Request for Information (RFI) Tracking Log
Solicitation: VA-248-15-R-0752
Project: 675-13-151
Title: Upgrade Restrooms, Lighting & Interior Finishes-Viera
RFI Tracking Log_RFI# 1-75
Thursday, April 16, 2015

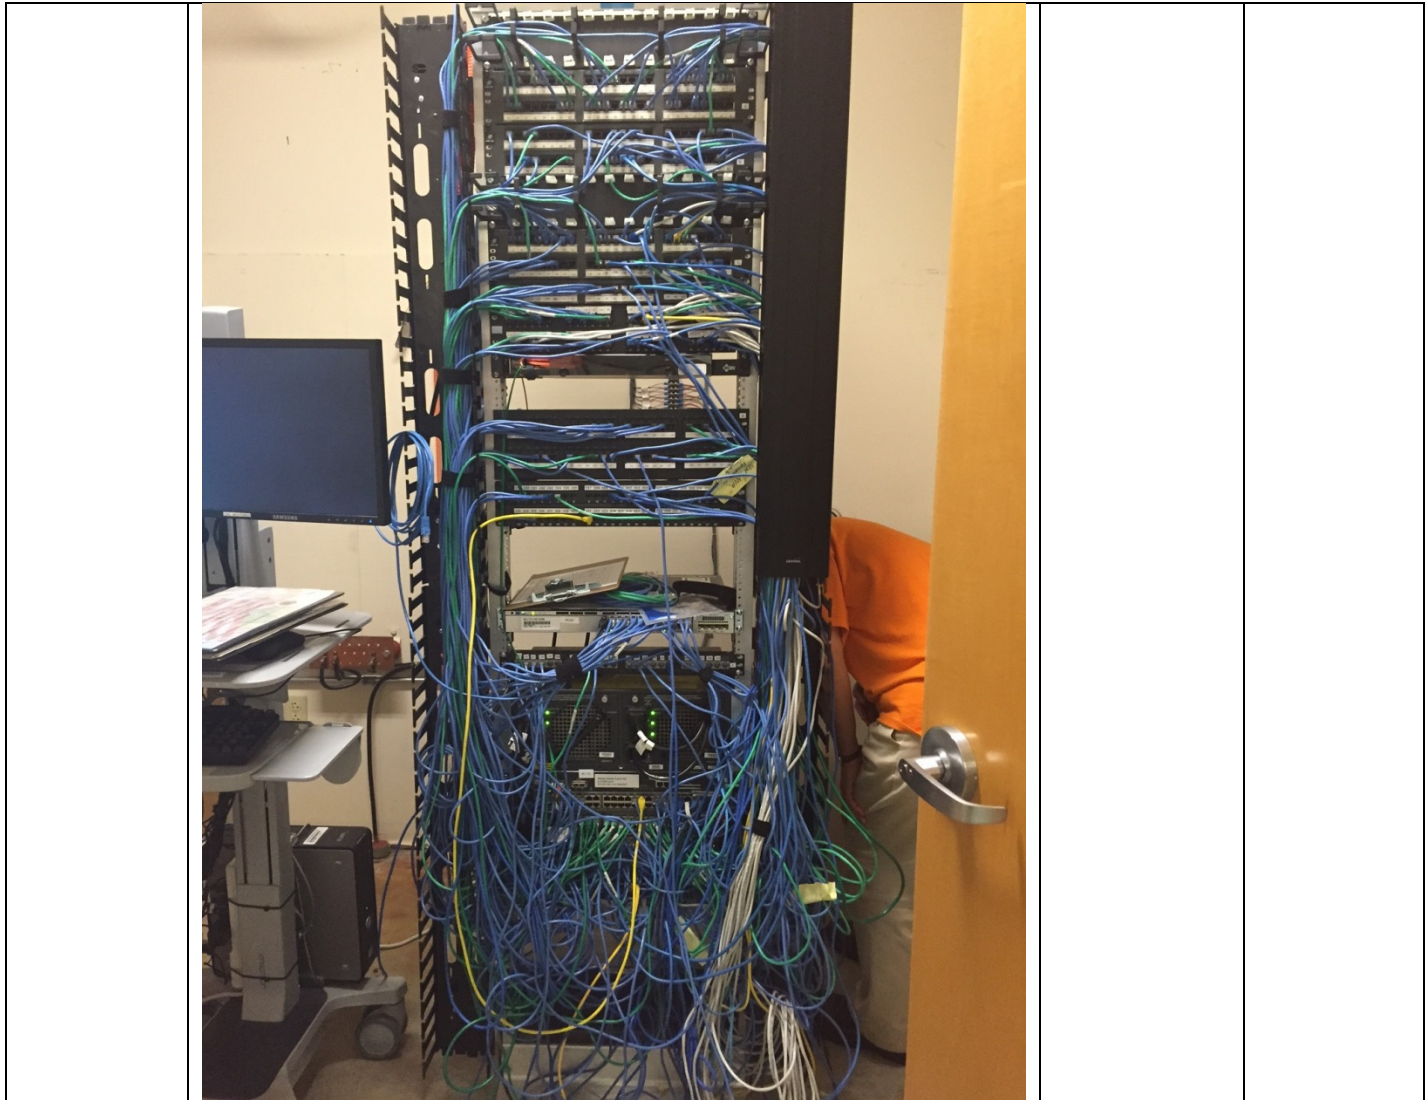
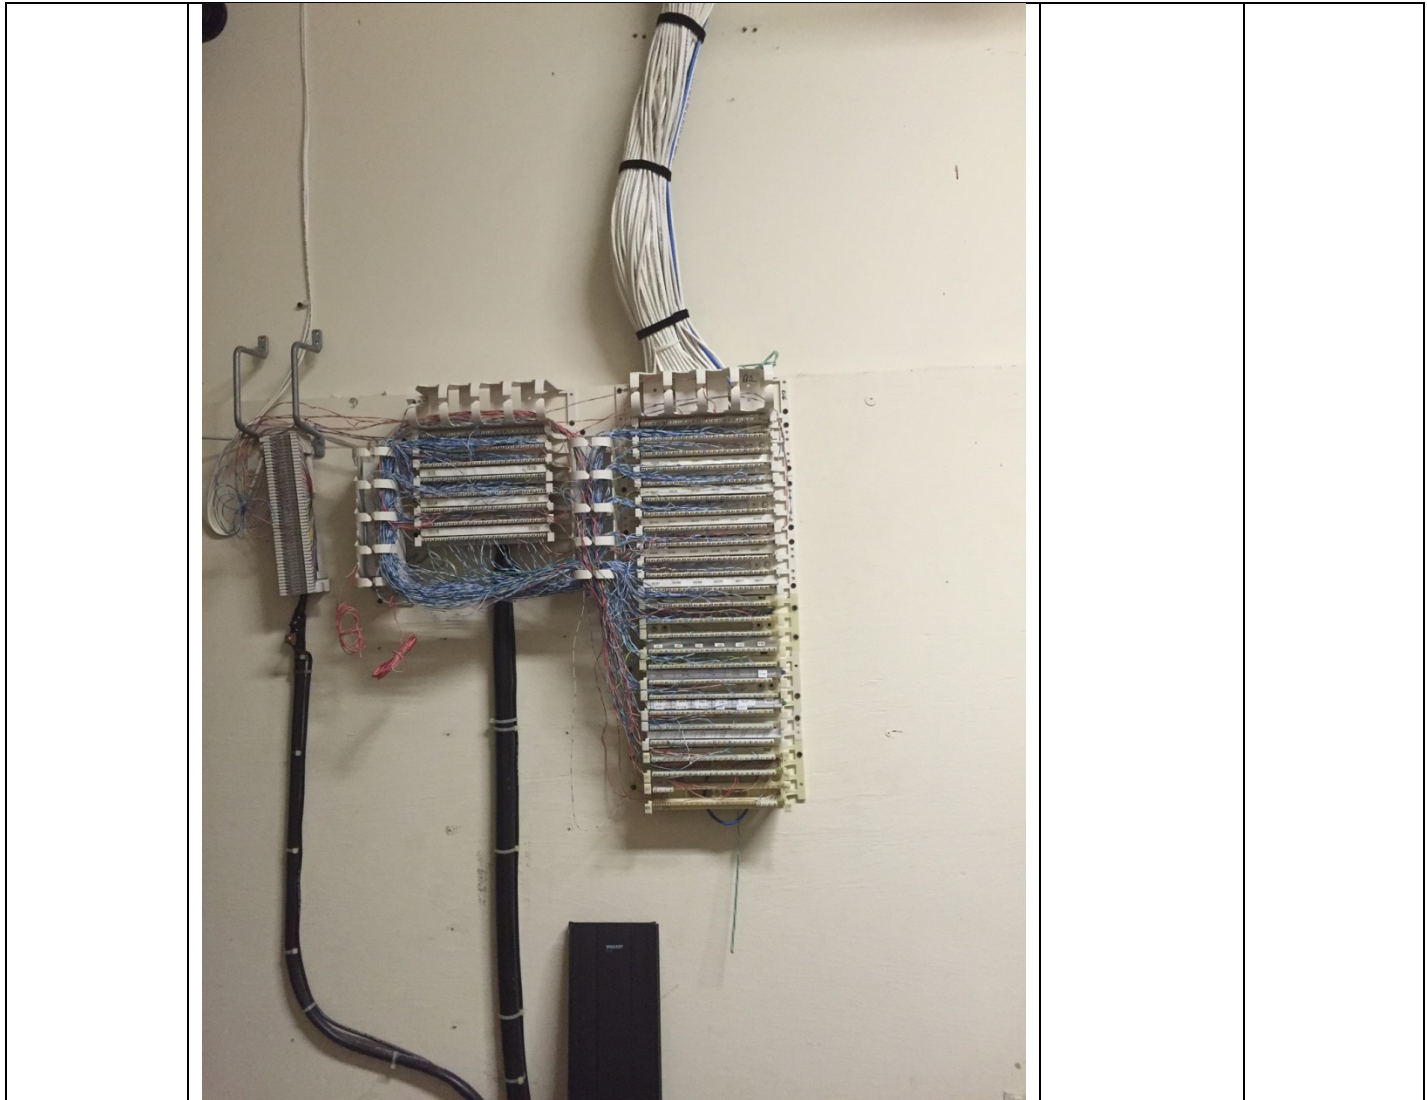
15.	(1) Can we please have access or pictures of Telecommunications Rooms A406 & Telephone Room/MDF A112 inside the Viera Veterans Affairs Building? Morse needs clarification on rack space, panel counts, fiber patch panel availability? Please advise?	Morse Communications	04-02-2015

Response	Providing Photos of data room cabling, data patch panels and phone punch down blocks in A112 and Fire Alarm Panel in A406A – Special site visit held 4/9/15. – All data and phone cabling to be 5E. Bid based on providing additional 48 port data patch panel and additional phone punch down block.
